Recall Campaign Bulletin

Campaign No. 2022090010, October 2022

SUBJECT: Models GLE-Class and GLS-Class (167, X167 platform) Model Year 2020-2022

Check Mounting of Rear Door Trim Bar

Figure 2

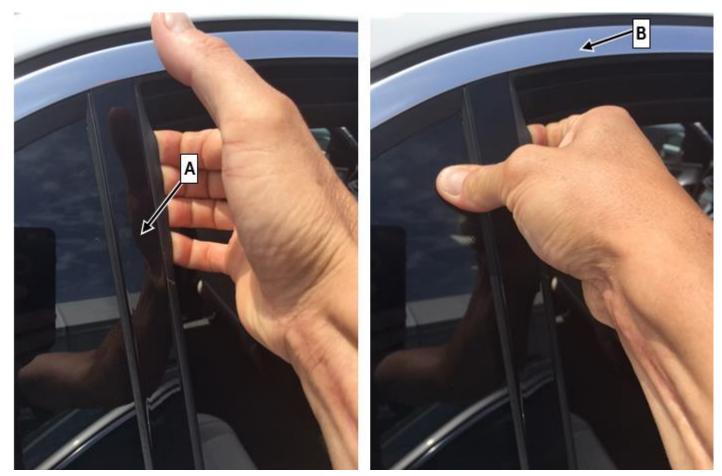
Ensure that the window divider is *not* jammed under the trim bar on the window frame

(B, Figure 2). This could cause a test error with regard to the holding ability of the trim element on the window divider. A gap of 1 mm from the window divider (A) to the window frame (B) is normal.

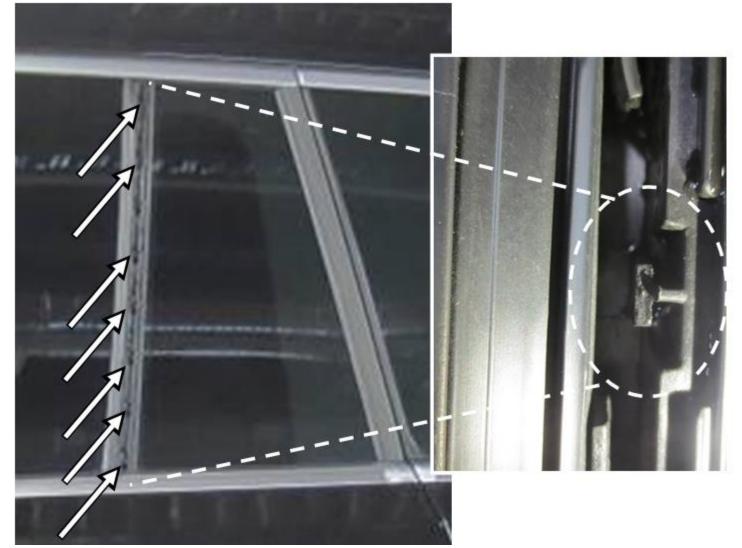
i If window divider is loose.

1. Remove window divider completely and check **holder for window divider** on frame of triangular window. **i** If no damage is visible, reinstall window divider and check again whether it is tightly seated

- a. Holder for window divider broken: Carry out work procedure.
- b. Holder for window divider *not* broken: End measure.
 Includes: Re-assembly of window divider
